Remarks

Amendments to the Specification and Drawings

Atty. Docket No. CPAC 1029-5 Appl. No. 10/681,583

5/20

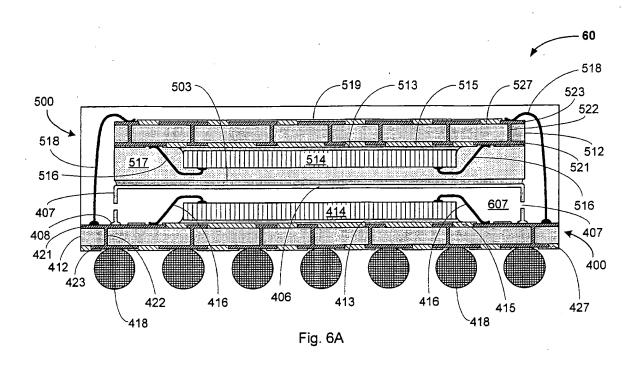
Additionally, Fig. **6B** is amended herein by insertion of missing reference numeral **406**, and **407** (2 instances), to be consistent with the description and with the reference numeration of Fig. **6A**.

6/20

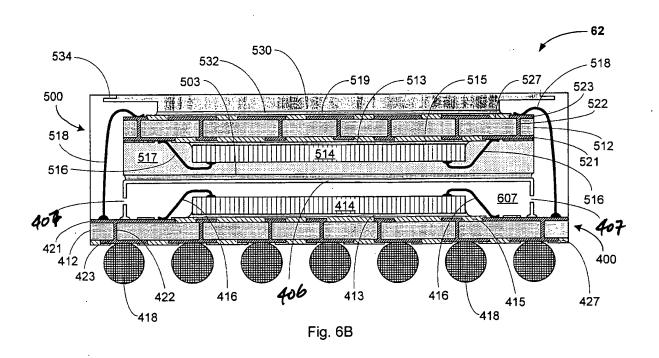
In Figs. 7A, 7B and 7C, the lead line from reference numeral 315 is moved, to indicate the "solder mask", see paragraph [00140]. It is noted that reference numeral 313 indicates the underfill, see paragraph [00136].

7 / 20

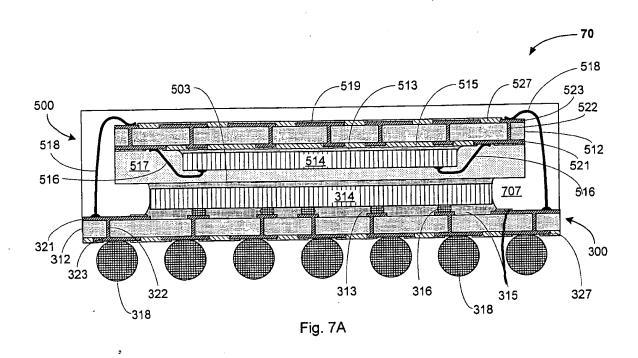
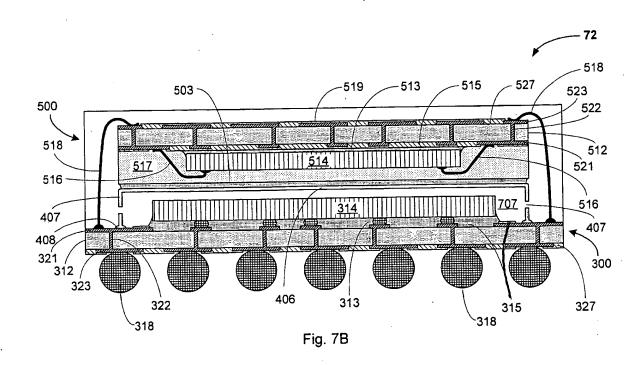
- -- 90, 92 -- is inserted following "embodiments of the invention" in paragraph [00180];
- "355" is replaced with -- 305 --, "356" is replaced with -- 306 --, and "354" is replaced with -- 304 -- (paragraph [00165]) to make the text consistent with the reference numeration of FIG. 8C and to avoid use of any reference numeral to identify more than one feature. It is noted that metal layer 355 is sandwiched between dielectric layers 354, 356 in bottom package substrate 342 (see, e.g., paragraph [00157], Figs. 8A, 8B, 8C). Accordingly, Fig. 8B is amended to make the reference numeration consistent with that of Fig. 8C, by replacing the instances of reference numerals 354, 355, 356 that are directed to the lower planar part and the legs or sidewalls of the heat spreader, and the adhesive by which the heat spreader is affixed to the substrate, with, respectively, numerals 304, 305, 306;
